Florida Department of Transportation

ROADWAY DESIGN BULLETIN 15-08
TRAFFIC OPERATION BULLETIN 03-15
(FHWA Approved: April 14, 2015)

SUBJECT: **Signing and Pavement Marking Standards at Ramp Intersections**

Figure 7.8.1 Diamond Interchange Exit Ramp

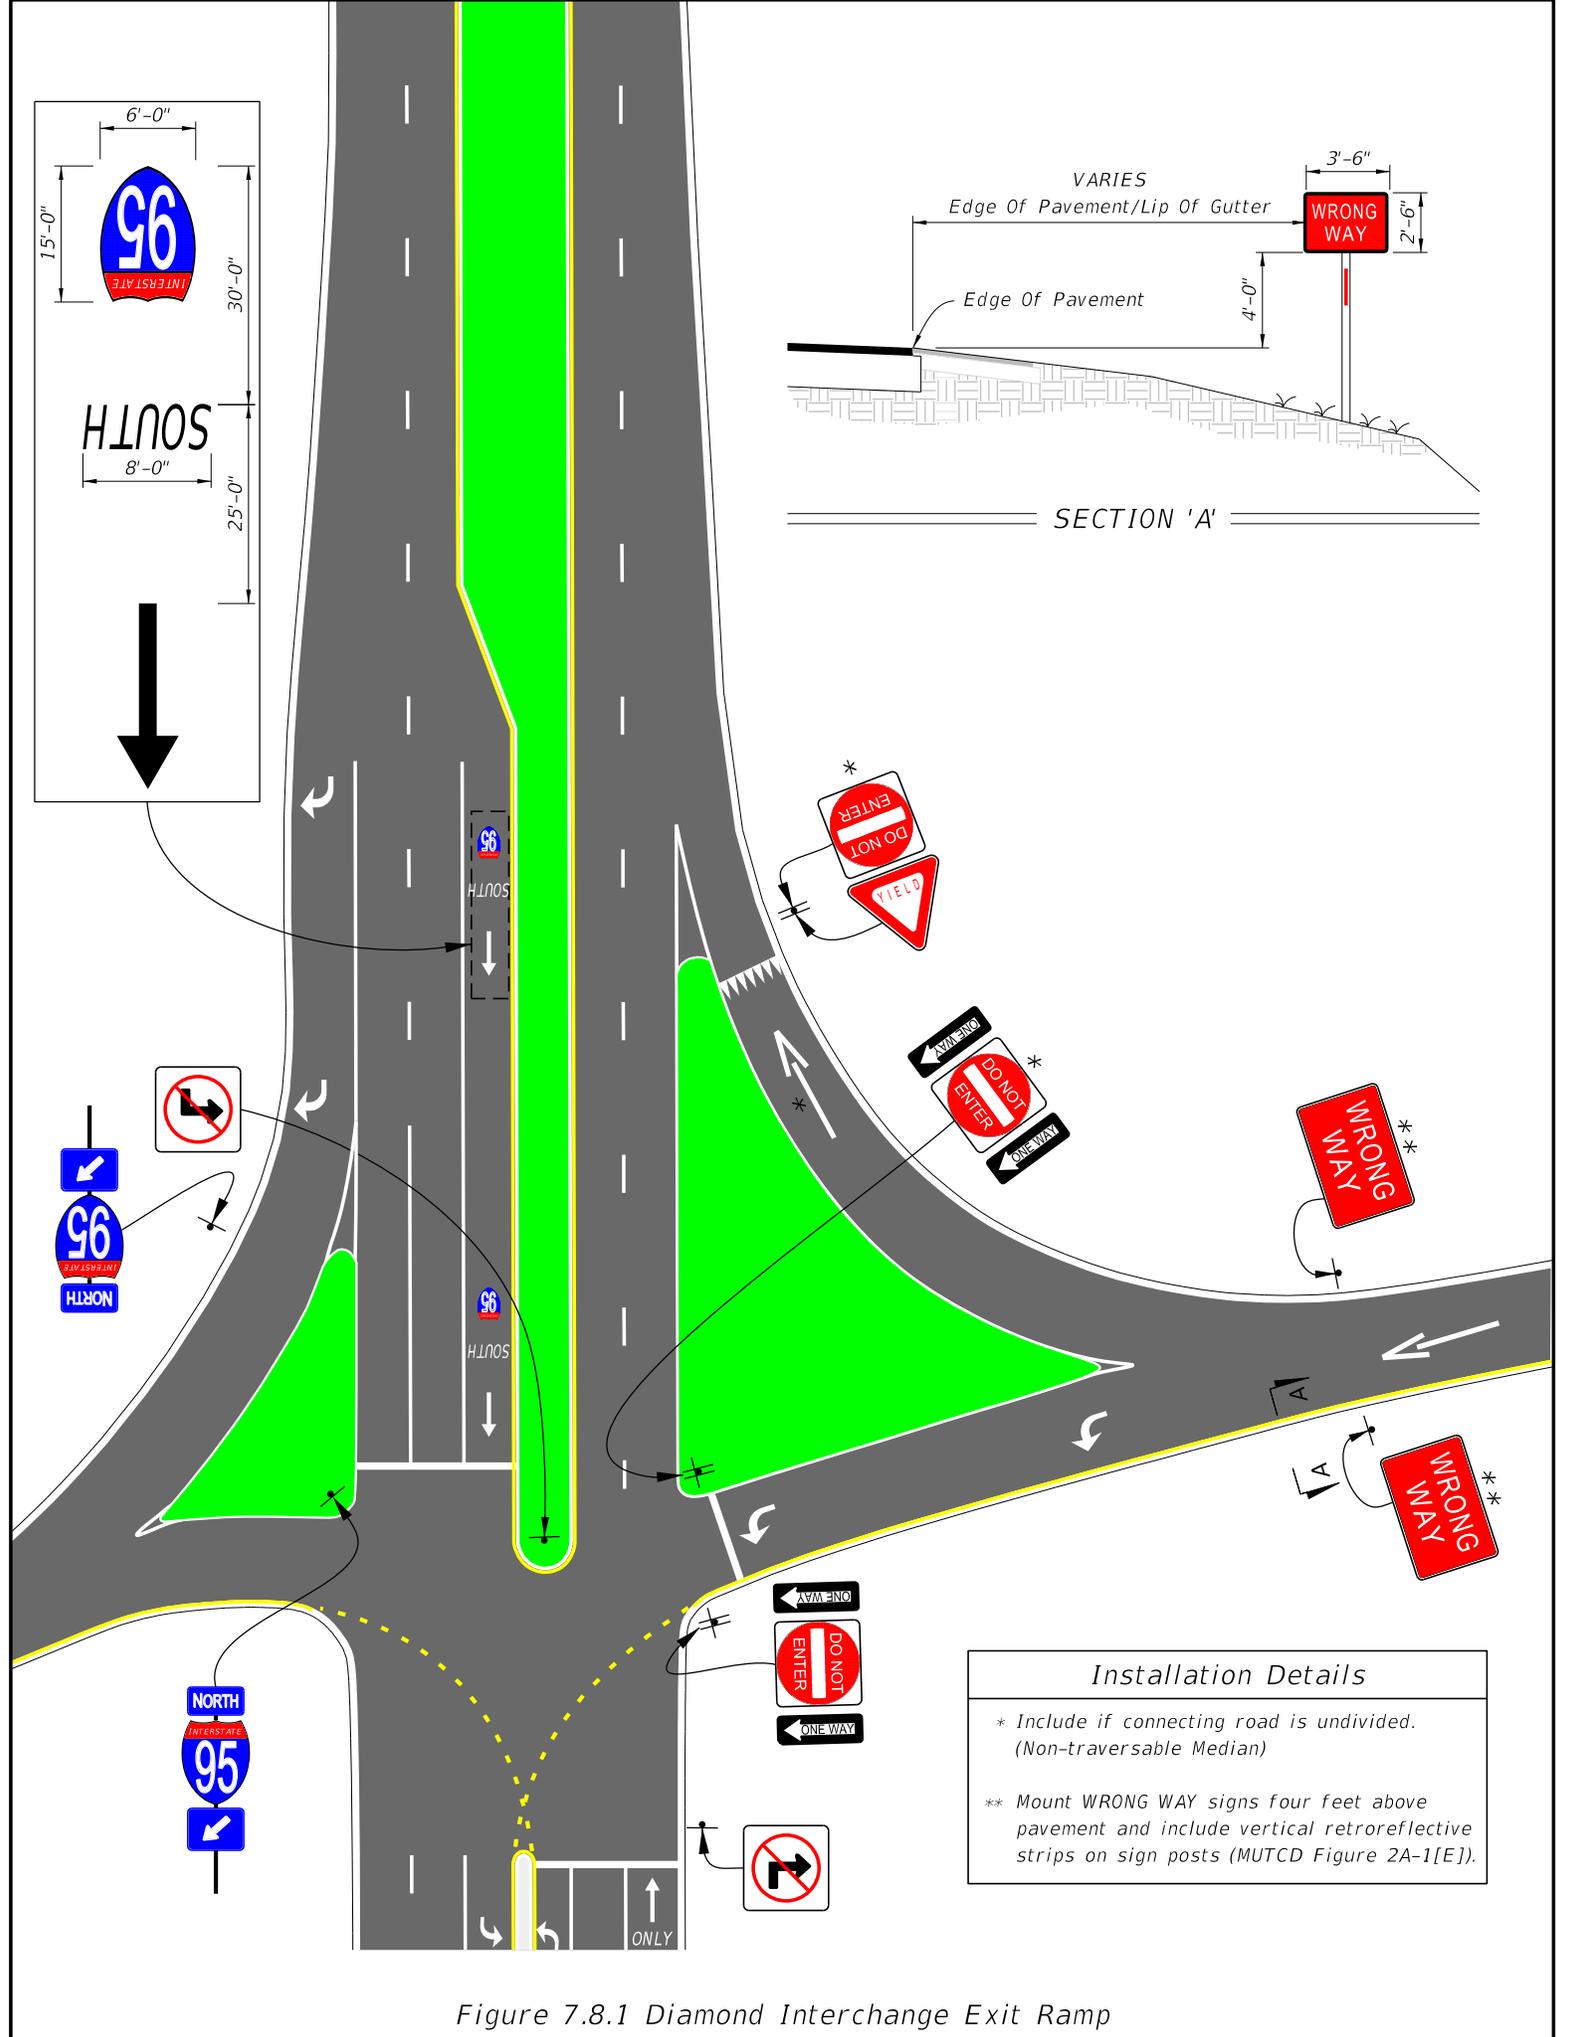
1. The new standard for signing and pavement marking at exit ramp intersections is illustrated in **Figures 7.8.1** "Diamond Interchange Exit Ramp" and **7.8.2** "Partial Cloverleaf/Trumpet Interchange Exit Ramp" and described as follows:
 - A. Include MUTCD "optional" signs
 - Second DO NOT ENTER sign
 - Second WRONG WAY sign
 - ONE WAY signs
 - B. Include NO RIGHT TURN and NO LEFT TURN signs

- C. Use 3.5 ft. by 2.5 ft. WRONG WAY signs mounted at 4-foot height with retroreflective strip on sign supports (MUTCD, Figure 2A-1[E])
- D. Include 2-4 dotted guide line striping for left turns between ramps entrances/exits and cross-streets
- E. Include retroreflective paint (yellow) on ramp median nose where applicable
- F. Include a straight arrow and route interstate shield pavement marking in left-turn lanes extending from the far-side ramp intersection through the near-side ramp intersection to prevent premature left turns
- G. Include a straight arrow and ONLY pavement message in outside lane approaching the ramp exit

- * Include if connecting road is undivided. (Non-traversable Median)
- ** Mount WRONG WAY signs four feet above pavement and include vertical retroreflective strips on sign posts (MUTCD Figure 2A-1[E]).
